Re: Fwd: Roofing Project Safety

DOE - Roof Project - U Building work

Fwd: Re: Re: DOE- Roof Project - Revised Out Building Shop Drawings with Requested Items

U Building Garage & Boiler House Roof Plan
07/26/2017

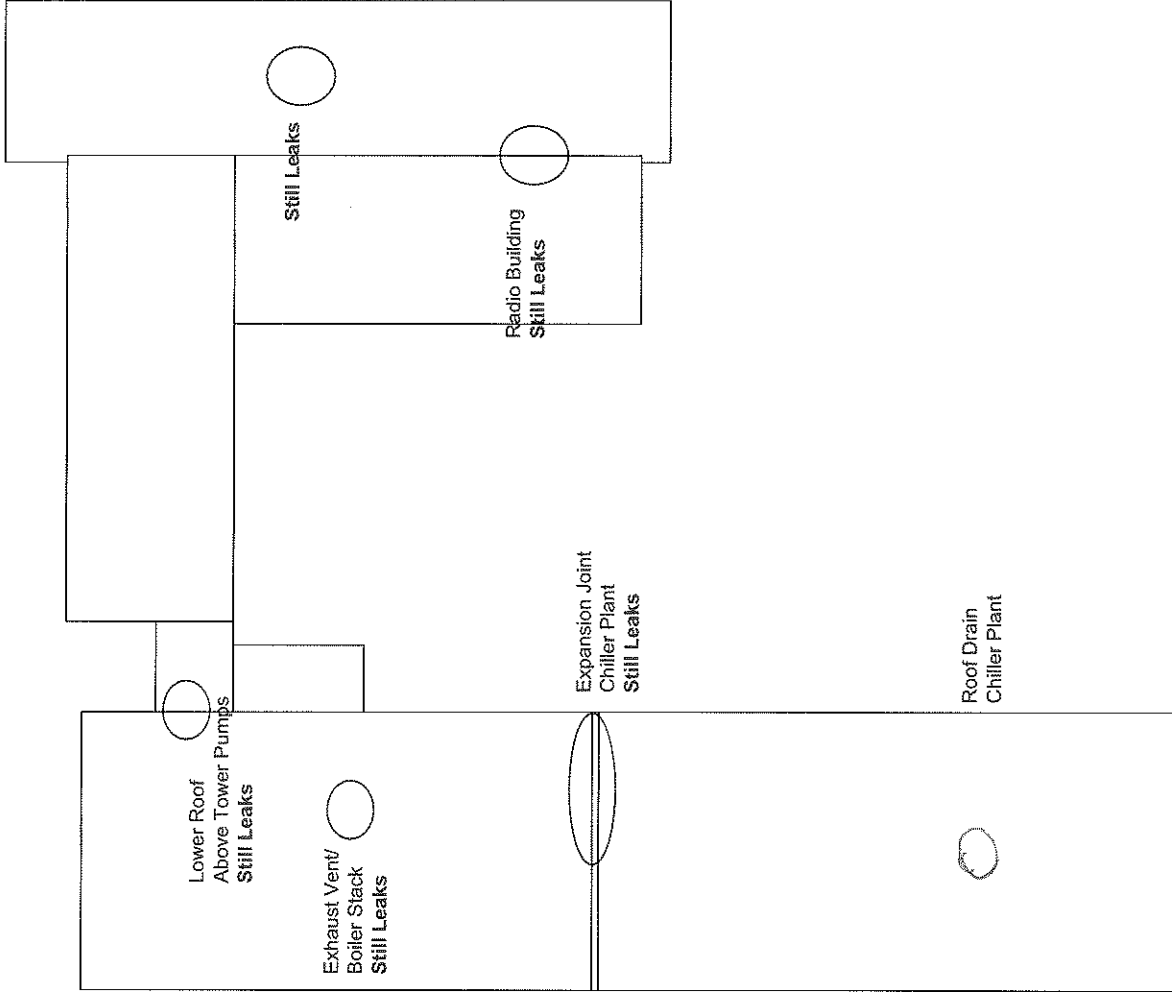
Regarding the U-Building roof project, please have the contractor STOP WORK until he has a method for removing materials safely from the roof. Throwing things off the roof is NOT an appropriate solution.

It appears that the roofing contractor is still dropping their roofing debris off the boiler plant roof without proper containment/protection.
